8198 CAMBIE STREET (COMPLETE APPLICATION)
DE415707 - ZONE CD-1 PENDING

DEVELOPMENT PERMIT STAFF COMMITTEE MEMBERS

DEVELOPMENT PERMIT STAFF COMMITTEE RECOMMENDATION: APPROVE

1 PARKING LEVEL P1 PLAN

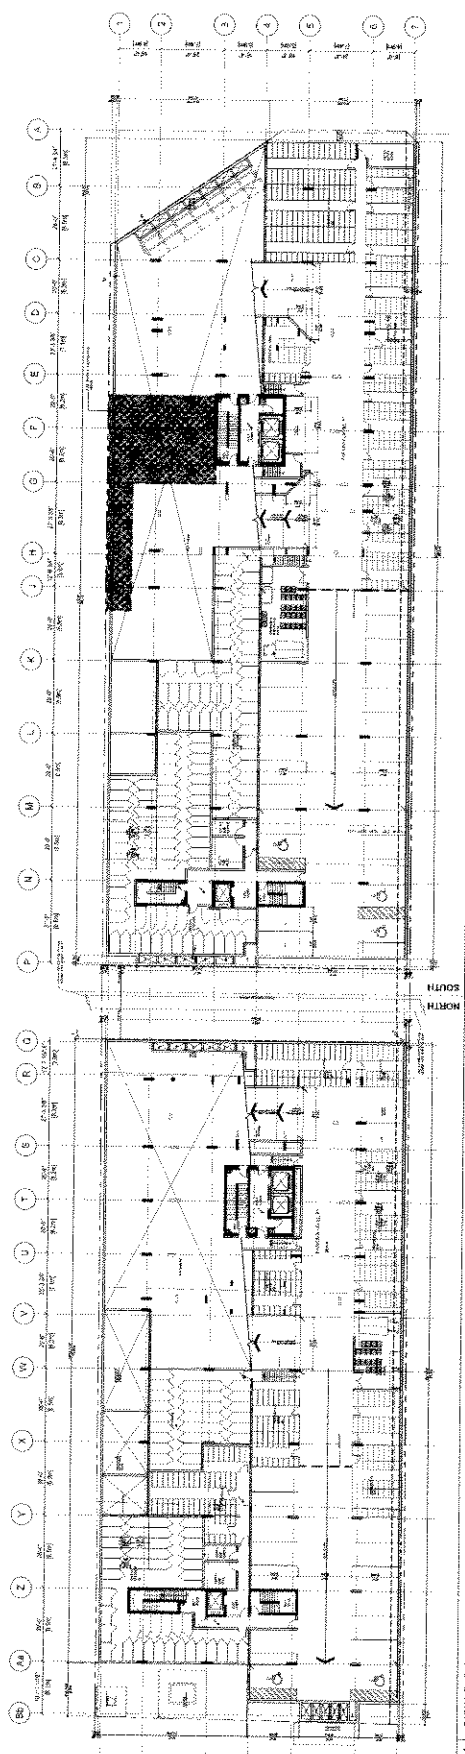
Note to Applicant: Although 70 storage lockers is noted for the rental (STIR) units on Parking Level P1 of the south tower, only 68 storage lockers are shown on the floor plan.

Note to Applicant: Provide dashed lines on the Parking Level 1 plan with note saying "proposed tree above: refer to Ground Floor Plan and Landscape Plan and Section.....". This is to ensure that trees planted above or immediately beside u/g parkades will survive and thrive. The section should detail how the parkade roof slab is depressed/angled back to accommodate 3-4' of tree soil depth.
